# Access Compliance Report

## Public Rights-of-Way

### (Curb Ramps)

Intersection ID: 13304	Main Street: GOLF_COURSE_LN	Cross Street: OLD_STEELE_CREEK_RD	Location: NE
ADA ID: CEAE4002492E	Ramp Type: PerpDiag	Initial Pass/Fail: Fail	Overall Compliance: No
Severity Score: 12.5			
Codes/Mitigation Info/Possible Solution		Field Measurements/Component Compliance

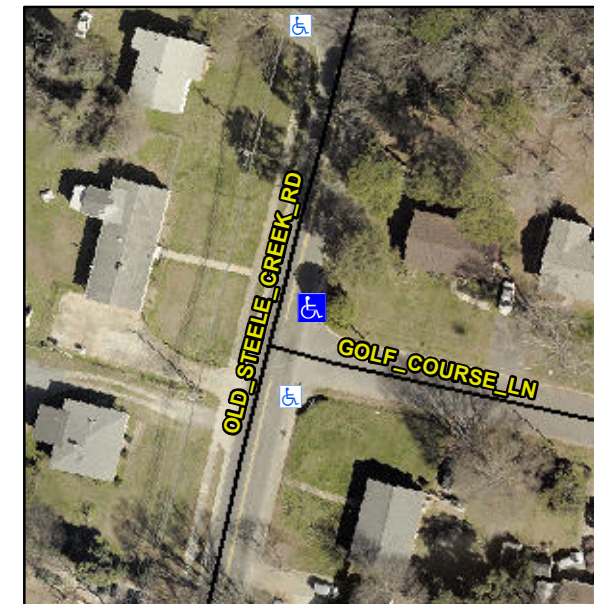
**Not Found, R304.5.3**

Compliance	Description	Data	Compliance	Description	Data
N/A	Ramp Length (in)	48.0	Yes	Ramp Slope (%)	6.9
Yes	Ramp Width (in)	48.0	No	Ramp XSlope (%)	5.8
N/A	Flare Type LT	N/A	N/A	Flare Type RT	N/A
N/A	Flare Slope LT (%)	N/A	N/A	Flare Slope RT (%)	N/A
N/A	Flare Traversable LT?	N/A	N/A	Flare Traversable RT?	N/A
N/A	Landing Length (in)	N/A	N/A	DWS Provided?	N/A
N/A	Landing Width (in)	N/A	N/A	DWS Contrast?	N/A
N/A	Landing Slope (%)	N/A	N/A	DWS Length (in)	N/A
N/A	Landing X Slope (%)	N/A	N/A	DWS Full Width?	N/A
N/A	Landing Curb? (Y/N)	N/A	N/A	DWS Offset (in)	N/A
N/A	Shared Landing?	N/A			
N/A	Gutter Ponding?	N/A	N/A	Gutter Slope (%)	N/A
N/A	Gutter Lip Ht (in)	N/A	N/A	Gutter X Slope (%)	N/A
N/A	Painted X Walk1?	No	N/A	Painted X Walk2?	No
	X Walk 1 Direction	To W		X Walk 2 Direction	To SW
N/A	X Walk 1 Width (in)	N/A	N/A	X Walk 2 Width (in)	N/A
	X Walk 1 Slope (%)	3.2		X Walk 2 Slope (%)	5.5
	X Walk 1 X Slope (%)	4.2		X Walk 2 X Slope (%)	0.9

**Remove & Replace Curb Ramp With Two New Directional Ramps or Equivalent.**
